APPLICATION NO.	FILING DATE	FIRST NAMED INVENTOR	ATTORNEY DOCKET NO.	CONFIRMATION NO.
10/653,249	09/03/2003	Harumichi Oishi	Q77285	2780
23373	7590	12/27/2005	EXAMINER	
SUGHRUE MION, PLLC 2100 PENNSYLVANIA AVENUE, N.W. SUITE 800 WASHINGTON, DC 20037			LANGDON, EVAN H	
			ART UNIT	PAPER NUMBER
			3654

Office Action Summary	Application No.	Applicant(s)
	10/653,249	OISHI ET AL.
	Examiner	Art Unit
	Evan H. Langdon	3654

DETAILED ACTION

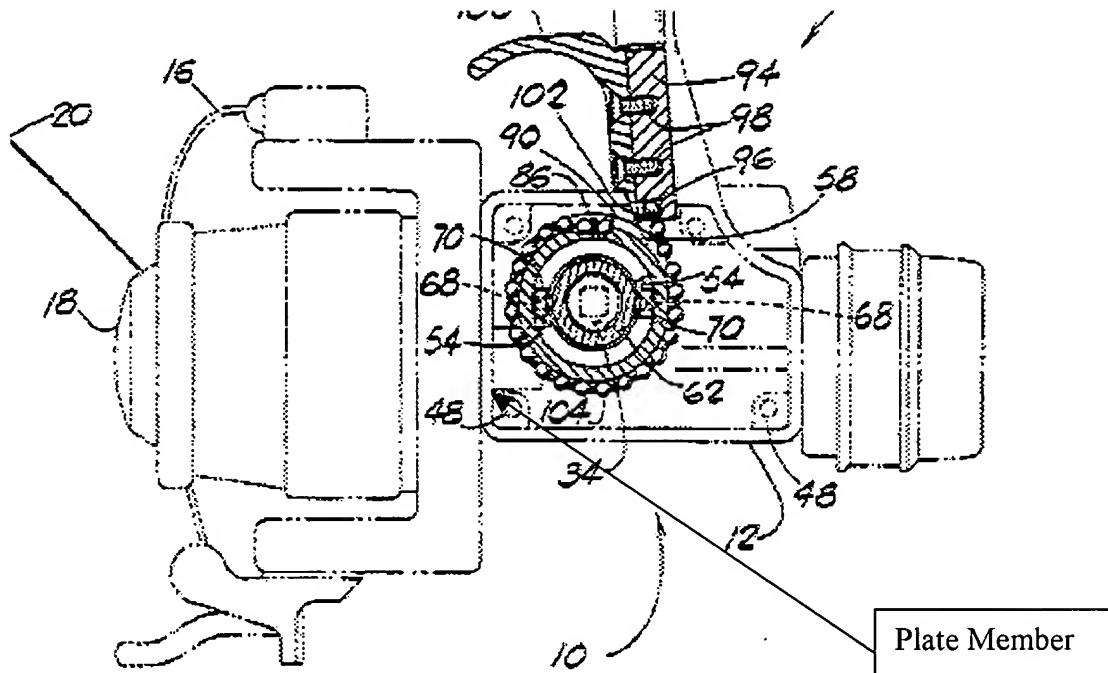
a plate connected between the left and right side plates to partially form an upper surface of the reel body, wherein the plate is respectively positioned between the operating member and a front-end of the reel body, and wherein the operating portion is projected upward from a surface of the plate (see below).
